## **ALERT SERVICE BULLETIN**

**429-22-58**

1 September 2022

**SUBJECT:** TRANSMISSION MOUNTED BELLCRANKS AND SUPPORT, INSPECTION OF

**Figure 1 - Transmission Mounted Bellcranks and Support, Inspection Of**

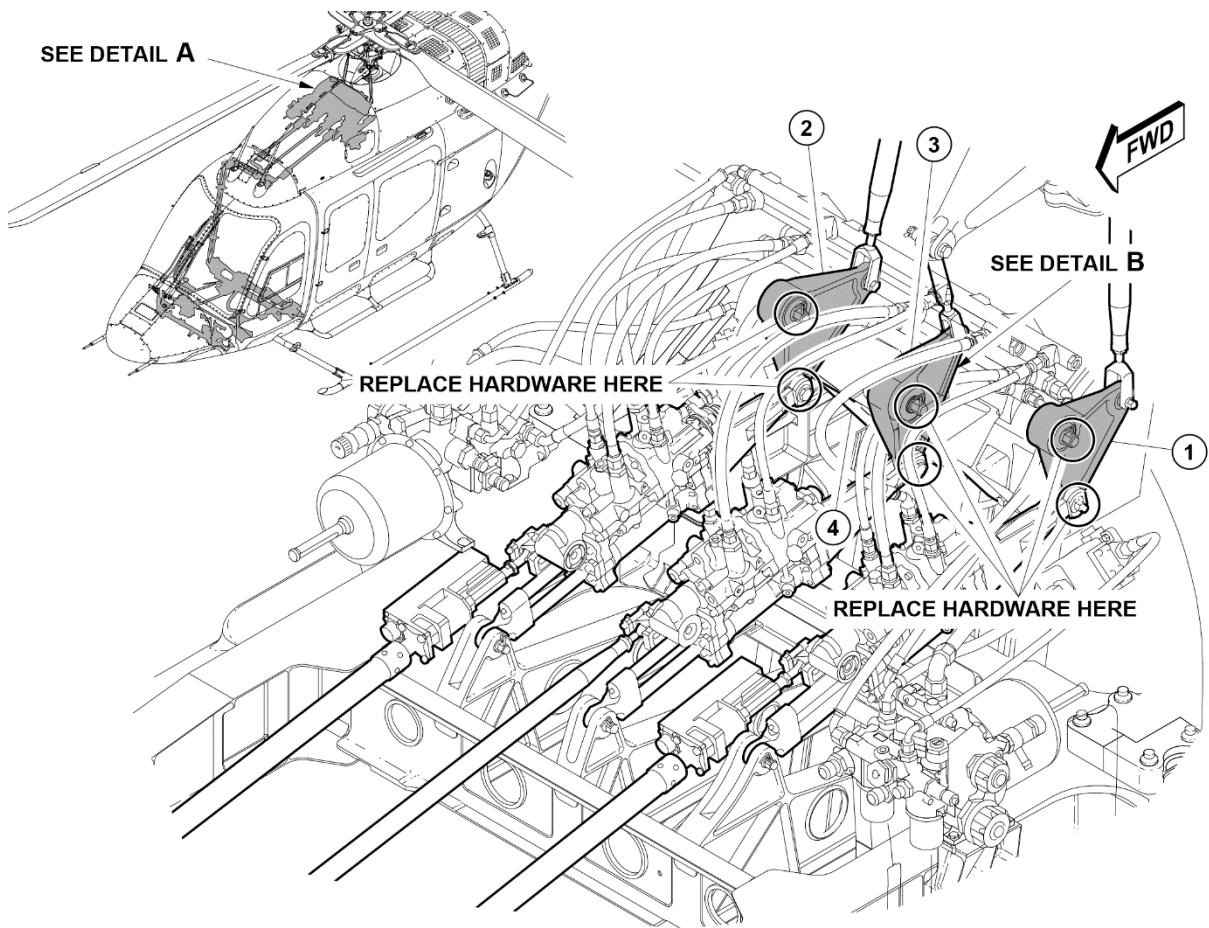
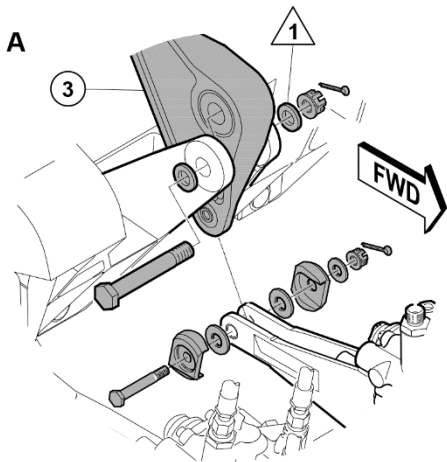
Bell has discovered that low torque values were applied to the transmission mounted cyclic and collective bellcranks and support hardware on the affected helicopters. If not corrected, the lack of preload may cause fretting which may cause a fatigue crack of the bolts or the bellcrank support. This ASB requires operators to inspect the transmission mounted bellcranks and support, replace the affected hardware and install with the correct torque values. This ASB also includes a design change to replace one aluminum washer with a CRES washer.

3. Remove the transmission mounted cyclic lateral bellcrank assembly (1, Figure 1), the cyclic longitudinal bellcrank assembly (2) (refer to Cyclic Control Linkage - Removal, DMC-429-A-67-10-00-11A-520A-A) and the collective bellcrank assembly (3) (refer to Collective Control Linkage - Removal, DMC-429-A-67-10-00-04A-520A-A). Discard the hardware (bolts, nuts, washers and cotter pins) at the three bellcrank assembly pivot joints and the three servo joints indicated in Figure 1.

4. Visually inspect the transmission mounted cyclic lateral and longitudinal bellcrank assemblies (1 and 2) (refer to Cyclic Control Linkage - Inspection, DMC-429-A-67-10-00-11A-310A-A), the collective bellcrank assembly (3) (refer to Collective Control Linkage - Inspection, DMC-429-A-67-10-00-04A-310A-A) and the transmission mounted bellcrank support (4) (DMC-429-A-67-10-00-18A-310A-A), paying particular attention for fretting damage in the pivoting area of the bellcrank assemblies and adjacent areas of the support.

5. Install the transmission mounted collective bellcrank assembly (3) (refer to Collective Control Linkage - Installation, DMC-429-A-67-10-00-04A-720A-A). Replace the aluminum washer NAS1149D0863J with a CRES washer NAS1149E0863P as per the Figure 1, Detail B. Torque pivot joint nut 40 to 58 FT-LBS. Torque servo joint nut 160 to 190 IN-LBS. Torque control tube nut 160 to 190 IN-LBS.

6. Install the transmission mounted cyclic lateral bellcrank assembly (1) and cyclic longitudinal bellcrank assembly (2) (refer to Cyclic Control Linkage - Installation, DMC-429-A-67-10-00-11A-720A-A). Torque pivot joint nuts 40 to 58 FT-LBS. Torque servo joint nuts 160 to 190 IN-LBS. Torque control tube nuts 100 to 140 IN-LBS.

1. Install CRES washer NAS1149E0683P.
